Product Change Notification

1. ECN #: 242713

- TFM - .050 X .050 MICRO STRIPS

- TFM-1XX-XX-X-DH-XX

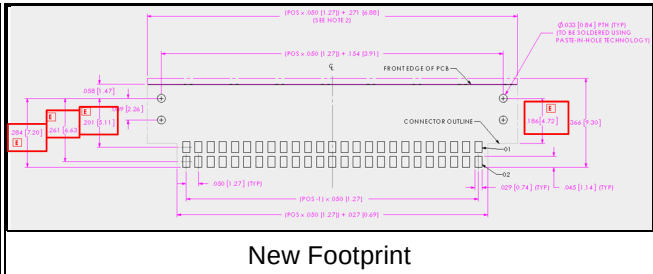
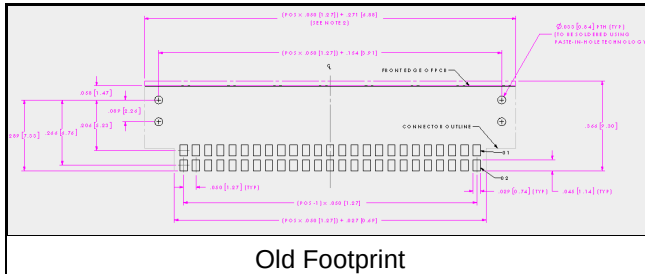
Updating the footprint layout to provide better part pin/leads to contact pad alignment.

The product design remains unchanged. The pad layout/footprint has been updated.

Provides better alignment of part leads to contact pad layout on mating PCB.

- Fit - Pad locations in reference to signal pin locations have been updated to better match the product.
